Technical Bulletin

Subject: **E-9 and E-10 Brake Valves**

FIG. 1

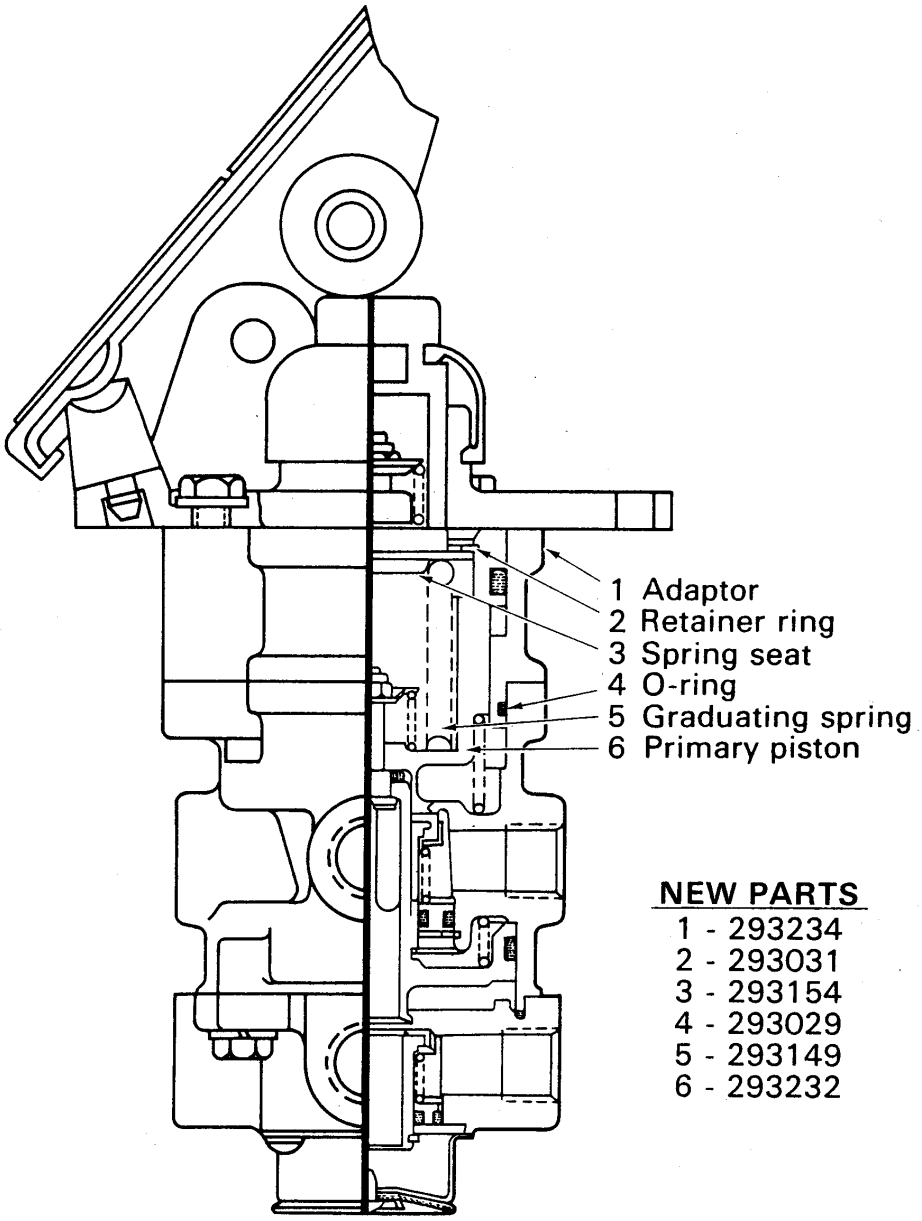
Fig. 1 shows a typical treadle type valve. The piece numbers which are added to the E-6 are shown.

NEW PARTS

1 - 293234
2 - 293031
3 - 293154
4 - 293029
5 - 293149
6 - 293232

FIG. 2

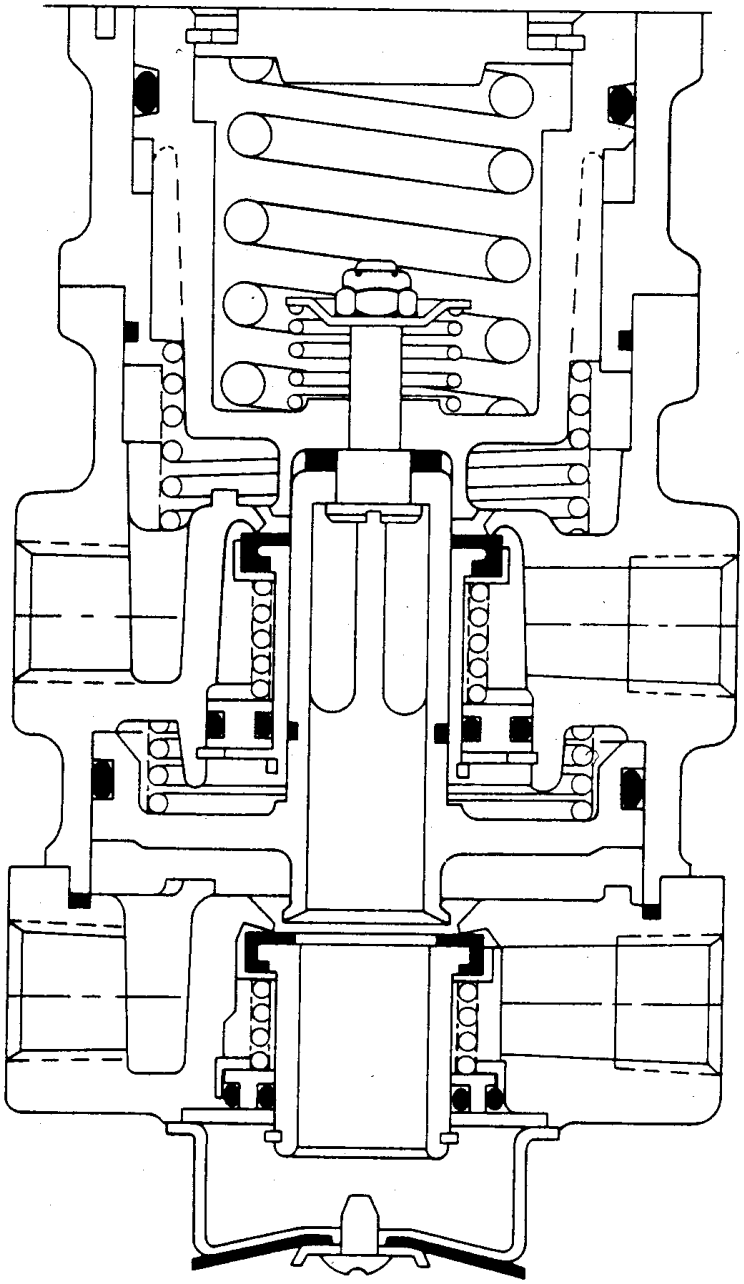
Fig. 2 shows a basic valve; piece number 101100 for the E-10. This is the piece number, which should be used for service replacement.
